Addendum No. 3
September 19, 2018

Project: **Sioux Falls Lutheran School**
Sioux Falls, South Dakota
Arch Project No. 2765

Architect: Architecture Incorporated

R8.30

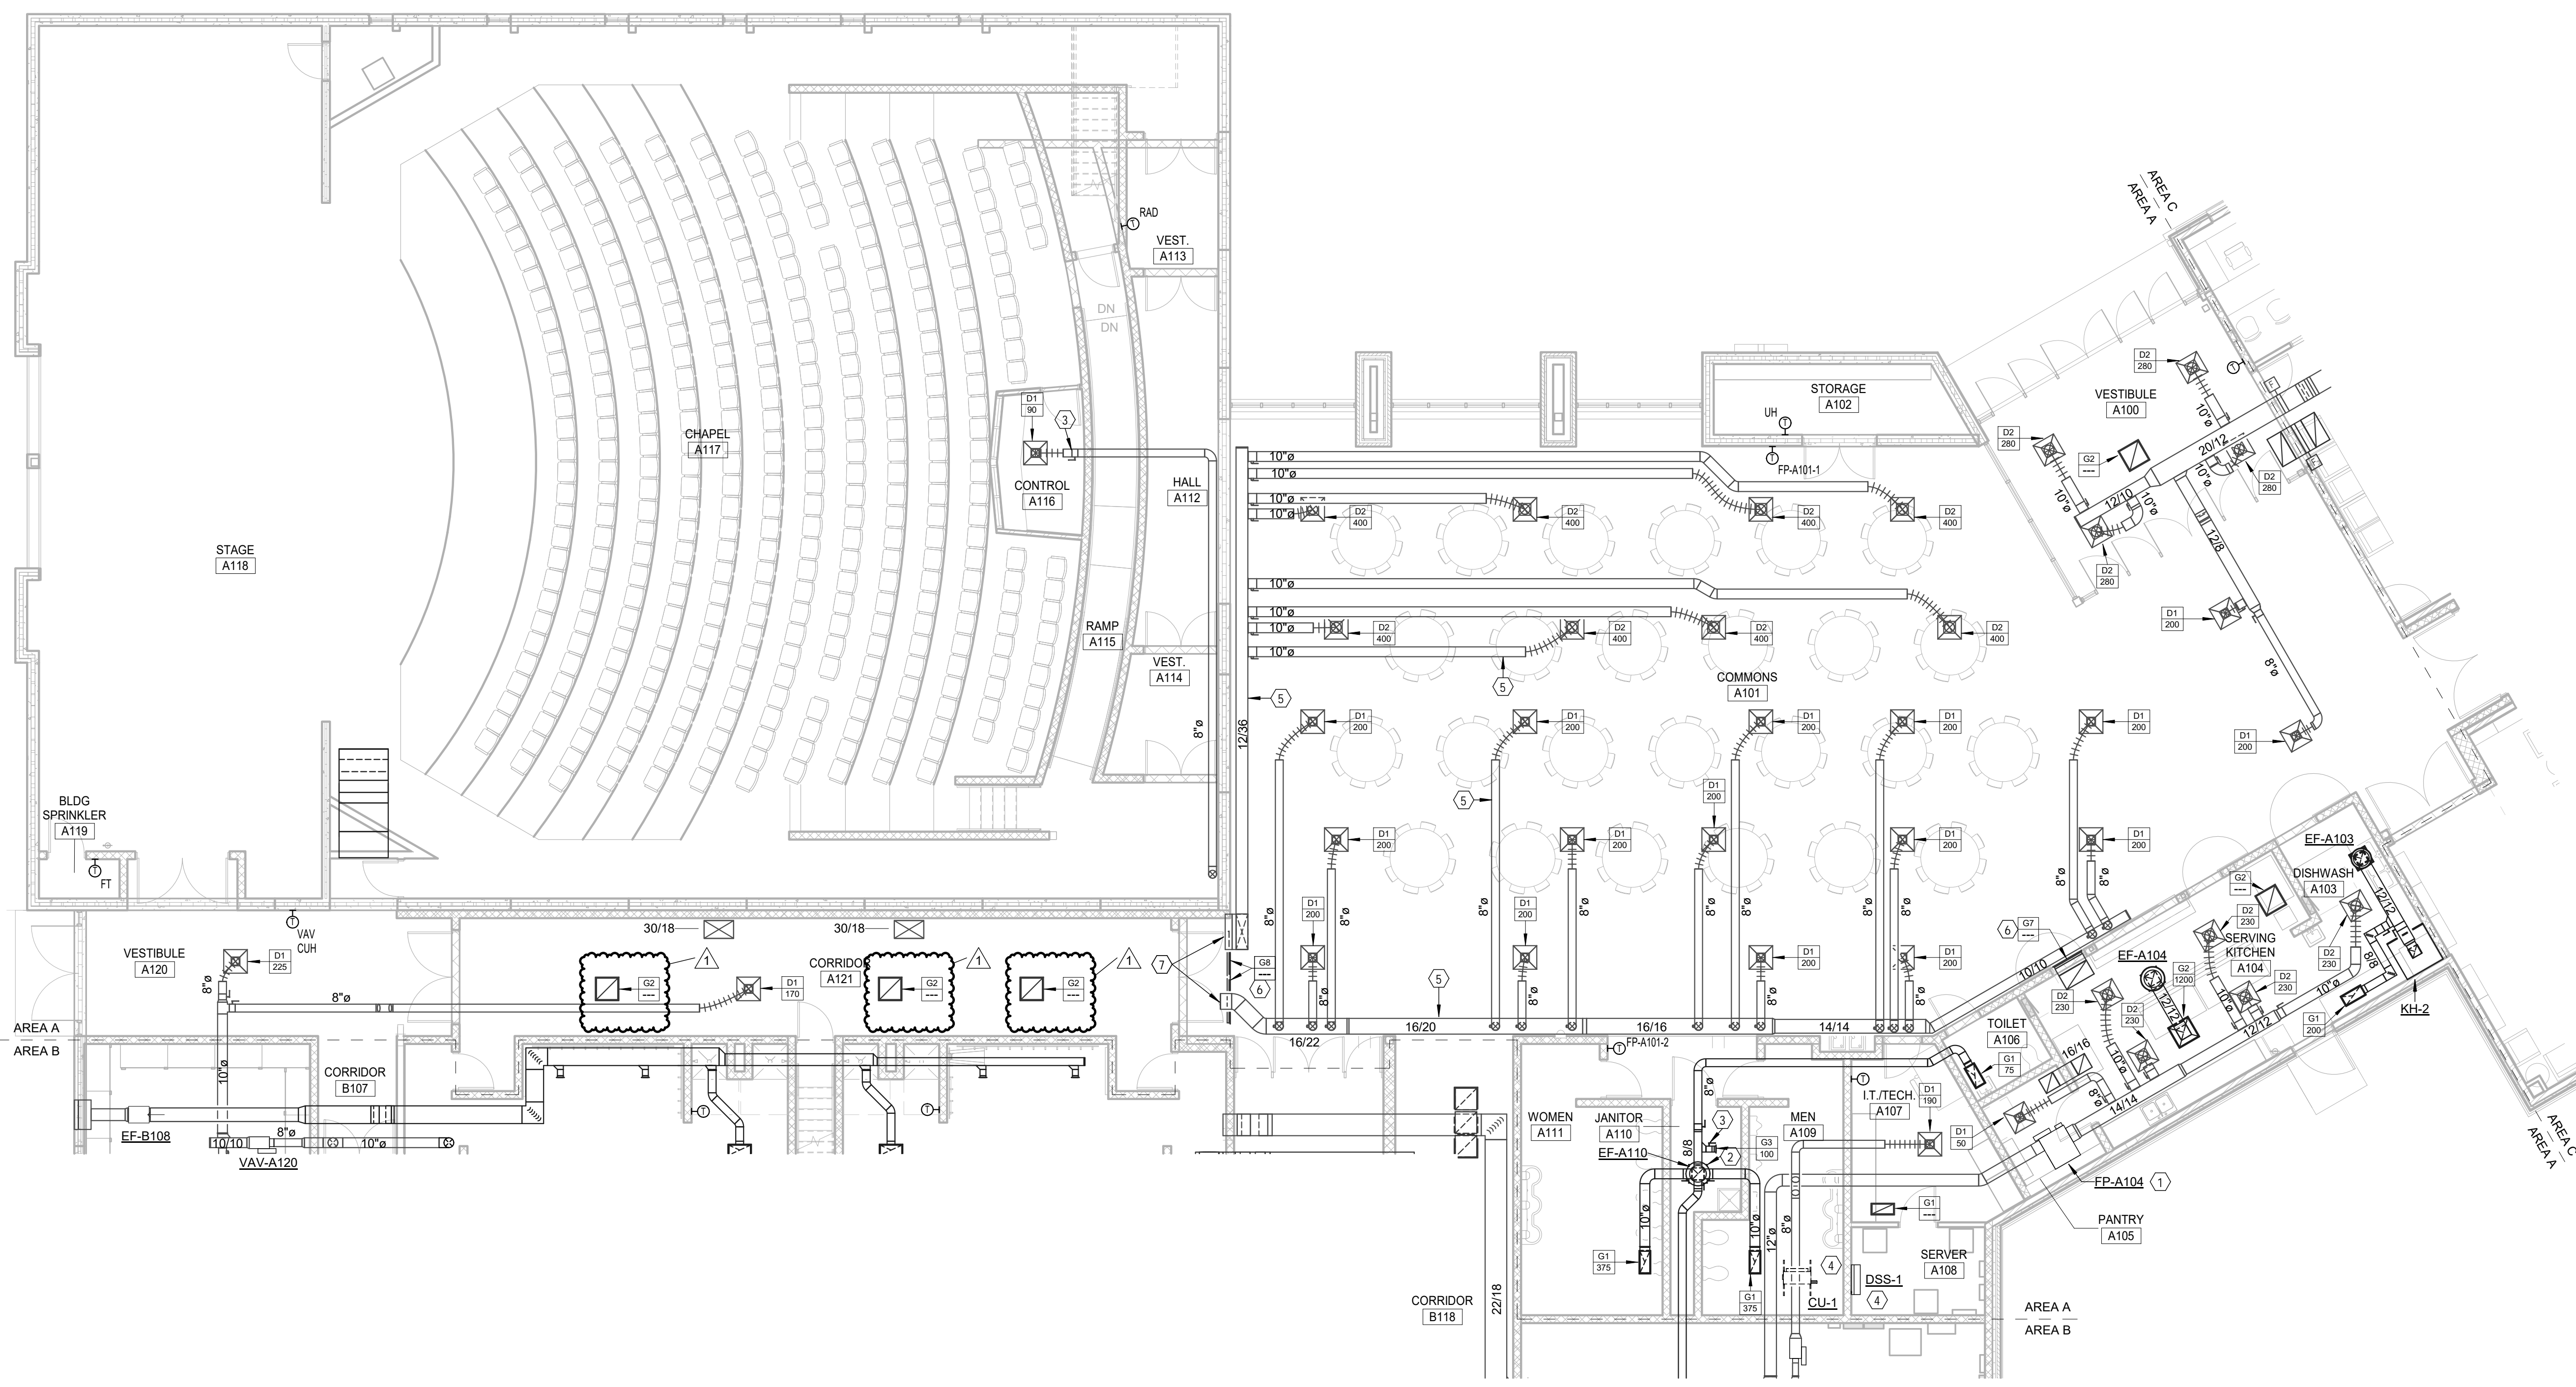
1) SHEET 8.30 – FLOOR PLAN – AREA A – VENTILATION & A/C:

- a) Corridor A121 - Add (3) G2 grilles.
 - i) Reference revised mechanical drawing Sheet R8.30, dated 9-19-18, attached to the end of this addendum.
